CAA Operational Assessment

Title of airspace change proposal	Northern LTMA Region Airspace Change (OFJES, CLN etc)
Change sponsor	NATS
Project reference	ACP-2025-023
Account Manager	[REDACTED]
Case study commencement date	10/10/2025
Case study report as at	05/12/2025
<p><i>Instructions</i></p> <p>In providing a response for each question, please ensure that the 'status' column is completed using the following options:</p> <ul style="list-style-type: none"> • YES • NO • PARTIALLY • N/A <p>To aid the SARG Lead it may be useful that each question is also highlighted accordingly to illustrate what is:</p> <p>resolved YES not resolved PARTIALLY not compliant NO...</p>

Executive Summary

Figure 3 Proposed CAS & relevant traffic flows via OFJES and OXDUF (Chart extract UK AIP ENR-6-7) – this is Option 2

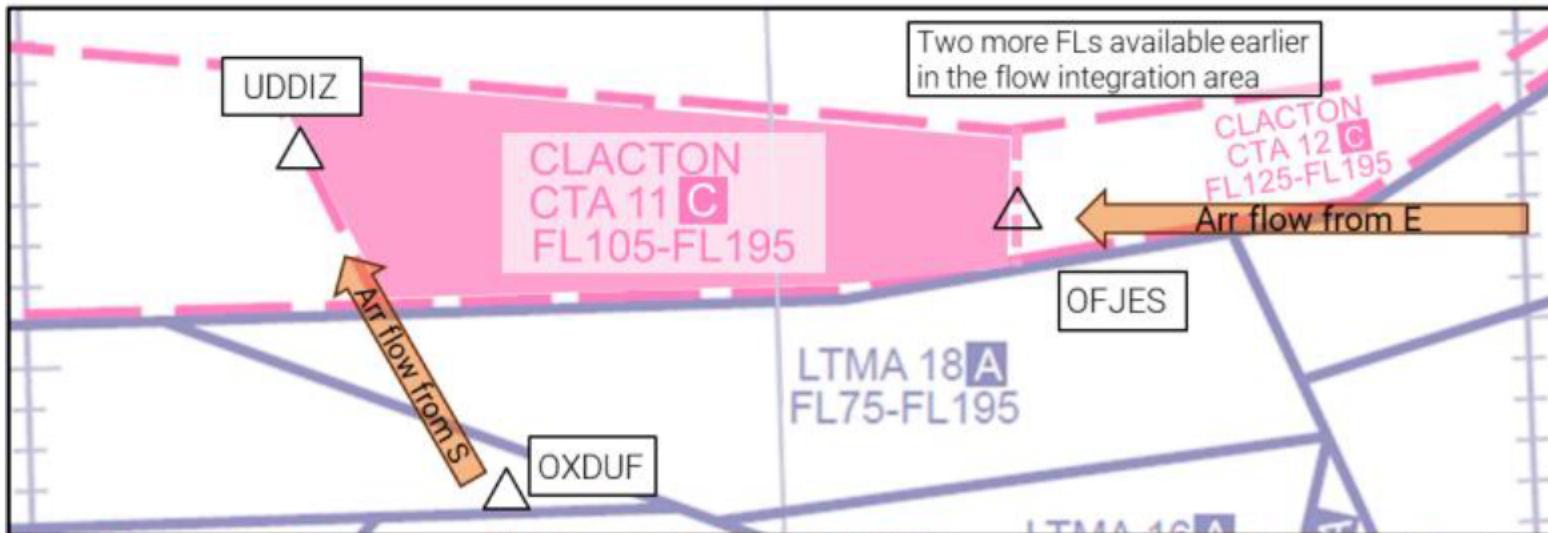
down selected to a favoured option (Option 2) which delivered the desired outcomes with the least impact on other airspace users – the most important of these being USAFE. A diagram of the proposed change is included below for reference (*Airspace Change Proposal Document, figure 3, p6*):
